WILKINSON COMMONS LA JOLLA POINTE DRIVE AND I-30 ROCKWALL, TEXAS RETAINING WALLS		 Childress Engineering Services, Inc. 2505 North Plano Road, Suite 1200 Richardson, Texas 75082 Office:(214) 451-6630 Fax:(214) 451-6631 CESGLOBAL.COM		MANUAL COMP 1 THC 08/11/07 REVISED WALL DESIGN REV BY DATE DESCRIPTION
---	--	---	--	---

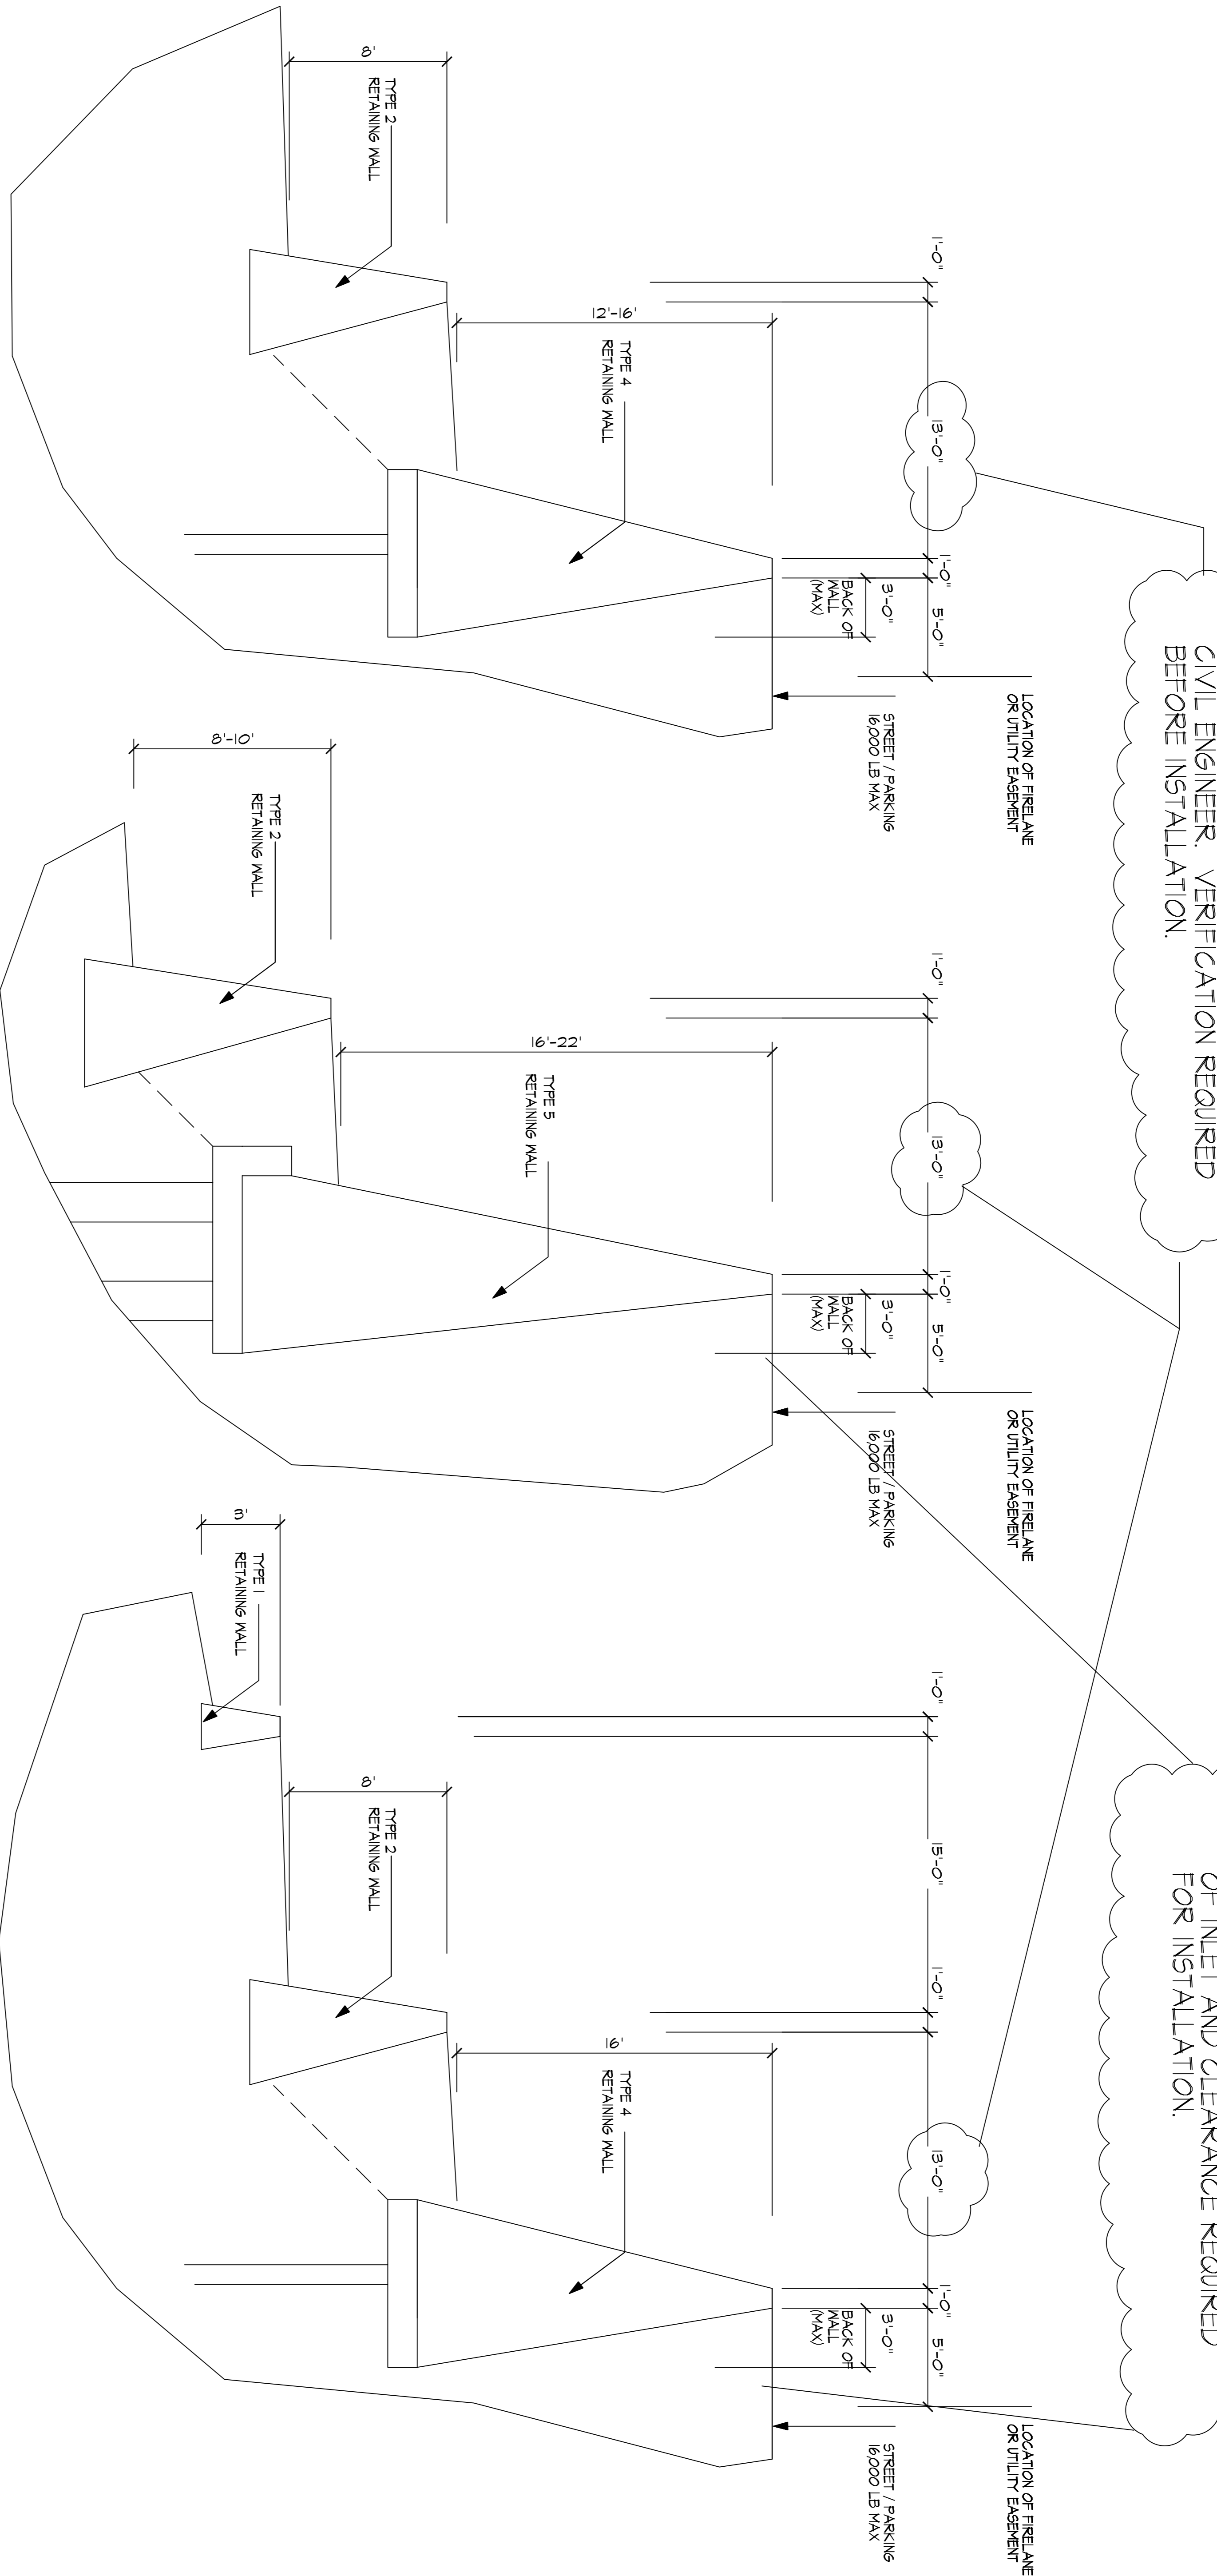
LOCATION OF WALL HAS BEEN MOVED FROM 11' TO 13' AS DISCUSSED WITH THE CIVIL ENGINEER. VERIFICATION REQUIRED BEFORE INSTALLATION.

CIVIL ENGINEER TO VERIFY SIZE OF INLET AND CLEARANCE REQUIRED FOR INSTALLATION.
